Office Action Summary	Application No. 10/539,148	Applicant(s) KANFLOD ET AL.	
	Examiner VICTOR MACARTHUR	Art Unit 3679

DETAILED ACTION

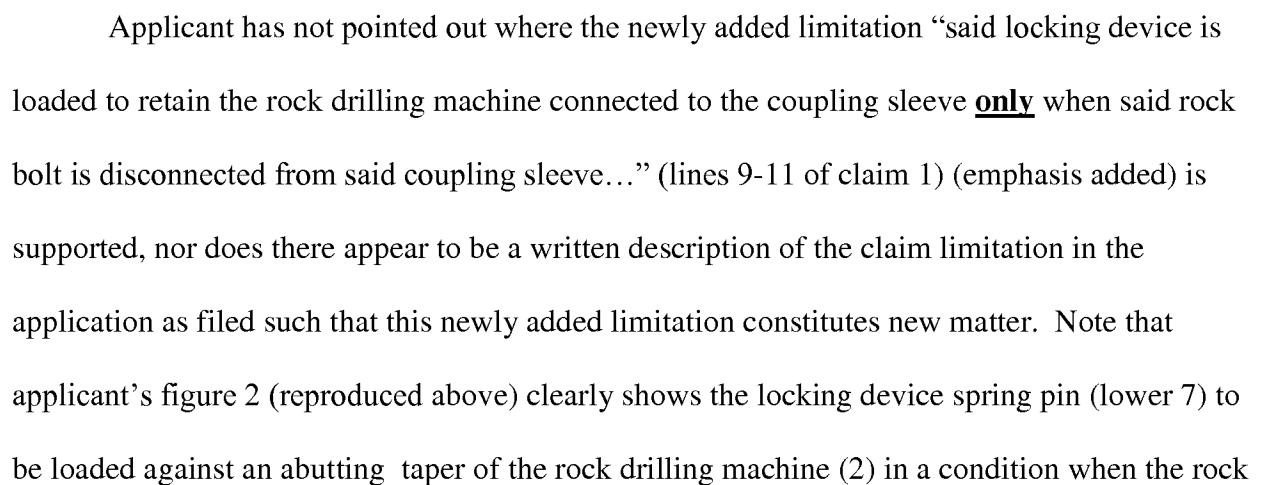
The drawings were received on 3/10/2011. These drawings are not acceptable since they contain new matter as shown below. Regarding figure 2, note that the space defined by elements (2, upper 10, and new matter line 100) is new matter. The originally filed figure 2 did not contain line 100, and thus the space defined thereby was originally occupied by a portion of element 3.

- The newly added recitation “as illustrated by Fig.2” (last paragraph of second page) which indicates that figure 2 shows “unloaded” is new matter. Note that figure 2 shows locking contact between lower pin (7) and the abutting taper of machine (2) such that it shows --loaded--. See applicant’s declaration filed 3/10/2011 which states (p.3, ll.3-8) that “loaded” is equivalent to “locked” while the term “unloaded” is equivalent to “unlocked”. Clearly pin (7) is as “locked” (loaded) as possible in figure 2. That is to say that there is no physical configuration of applicant's invention that is any more locked or loaded than that which is shown in figure 2, such that calling figure 2 “unloaded” amounts to new matter.

Applicant is required to cancel the new matter in the reply to this Office Action.

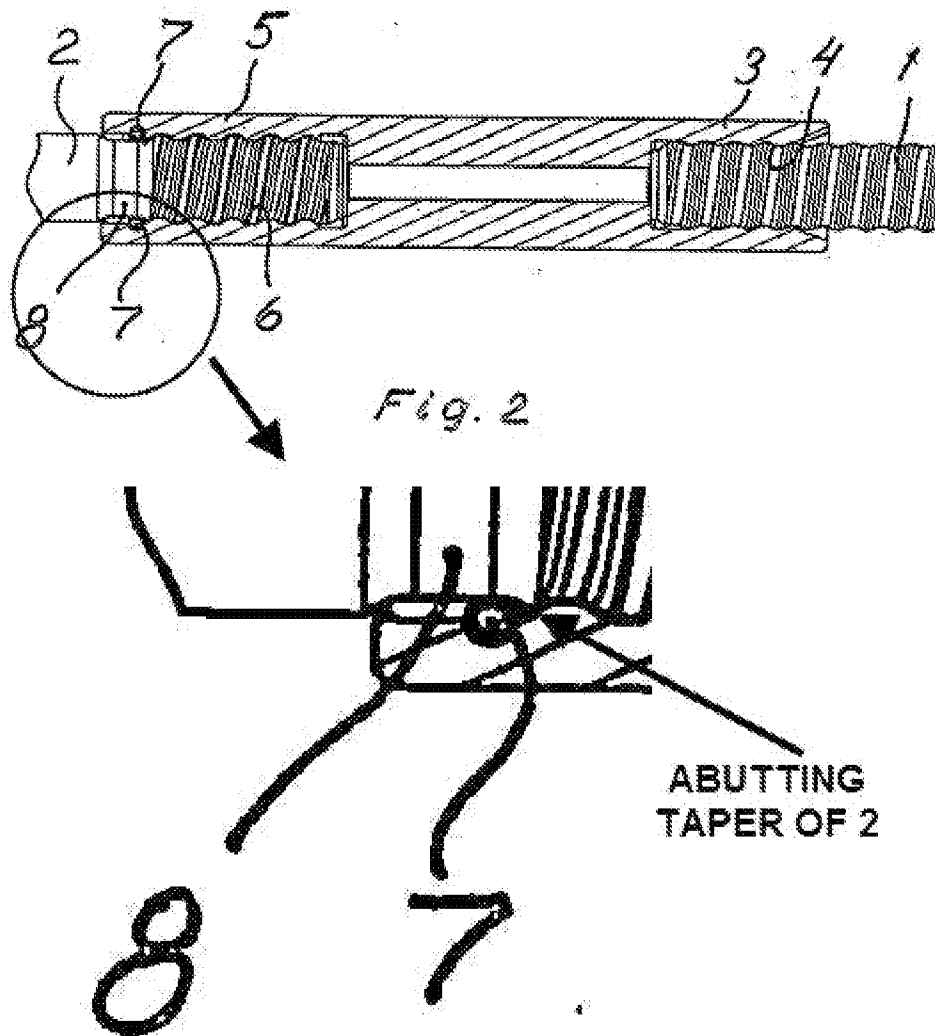
bolt (1) is connected to the coupling sleeve (3, 5). In fact even if figure 2 depicted locking device (7) to be unloaded (although it appears loaded) there is no structure to prevent the loading of locking device (7) to retain the rock drilling machine (2) connected to the coupling sleeve (3, 5) regardless of whether or not rock bolt (1) is connected or disconnected, since rock bolt (1) has no contact with either of locking device (7) or drilling machine (2) (even when the bolt is installed) and thus cannot prevent relative loading between device (7) and machine (2).

It is unclear how “said locking device is loaded to retain the rock drilling machine connected to the coupling sleeve only when said rock bolt is disconnected from said coupling sleeve...” (lines 9-11 of claim 1). Particularly, what structure would prevent loading of locking device (7) when one attempts to remove rock drilling machine (2) from sleeve (5, 3) while the rock bolt (1) remains connected to sleeve (5, 3)? Does applicant mean for the limitation as merely one possible intended use rather than a structurally limiting feature of the product? See applicant’s figure 2 above, which shows that there is no structure to prevent said locking device

(7) from being loaded against the abutting taper of said machine (2) to retain the rock drilling machine connected to the coupling regardless of whether said rock bolt (1) is disconnected or connected from said coupling sleeve (5, 3) since the rock bolt is not the sole source of all possible applied loads.

Note that applicant has argued that figure 2 shows pin (7) in a loaded position and figure 3 shows pin (7) in an unloaded position. However, both figures show pin (7) in identical positions (i.e., physically abutting the tapered portion of machine (2)). It is unclear how the claimed “unloaded” (claim 1) and “loaded” (claim 1) states structurally differ from one another.
